# Access Compliance Report

## Public Rights-of-Way

### (Curb Ramps)

Intersection ID: 47850	Main Street: LAGO_VISTA_CT	Cross Street: SERAPE_RD	Location: NE
ADA ID: 1745401E1BD3	Ramp Type: Perp	Initial Pass/Fail: Fail	Overall Compliance: No
Severity Score: 21.25			
Codes/Mitigation Info/Possible Solution		Field Measurements/Component Compliance

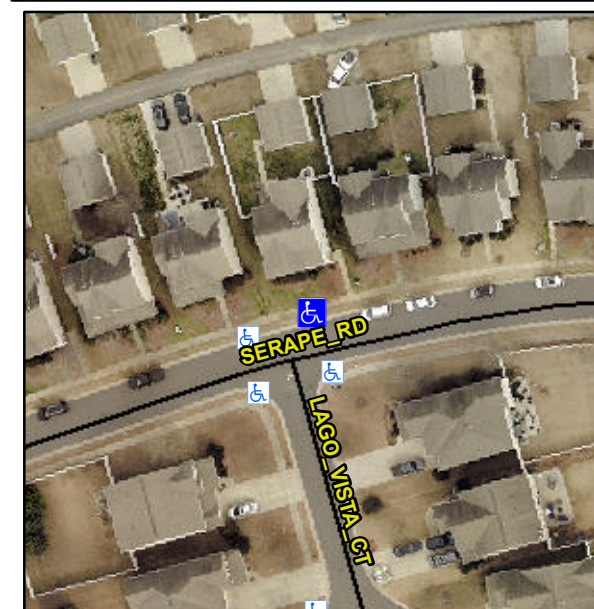
**R304.5.1, R304.2.2**

Compliance	Description	Data	Compliance	Description	Data
N/A	Ramp Length (in)	47.0	No	Ramp Slope (%)	9.1
No	Ramp Width (in)	47.0	Yes	Ramp XSlope (%)	1.9
N/A	Flare Type LT	N/A	N/A	Flare Type RT	N/A
N/A	Flare Slope LT (%)	N/A	N/A	Flare Slope RT (%)	N/A
N/A	Flare Traversable LT?	N/A	N/A	Flare Traversable RT?	N/A
N/A	Landing Length (in)	N/A	N/A	DWS Provided?	N/A
N/A	Landing Width (in)	N/A	N/A	DWS Contrast?	N/A
N/A	Landing Slope (%)	N/A	N/A	DWS Length (in)	N/A
N/A	Landing X Slope (%)	N/A	N/A	DWS Full Width?	N/A
N/A	Landing Curb? (Y/N)	N/A	N/A	DWS Offset (in)	N/A
N/A	Shared Landing?	N/A			
N/A	Gutter Ponding?	N/A	N/A	Gutter Slope (%)	N/A
N/A	Gutter Lip Ht (in)	N/A	N/A	Gutter X Slope (%)	N/A
N/A	Painted X Walk1?	No	N/A	Painted X Walk2?	N/A
	X Walk 1 Direction	To S		X Walk 2 Direction	N/A
N/A	X Walk 1 Width (in)	N/A	N/A	X Walk 2 Width (in)	N/A
	X Walk 1 Slope (%)	2.9		X Walk 2 Slope (%)	N/A
	X Walk 1 X Slope (%)	0.9		X Walk 2 X Slope (%)	N/A

**Remove & Replace Entire Ramp.**
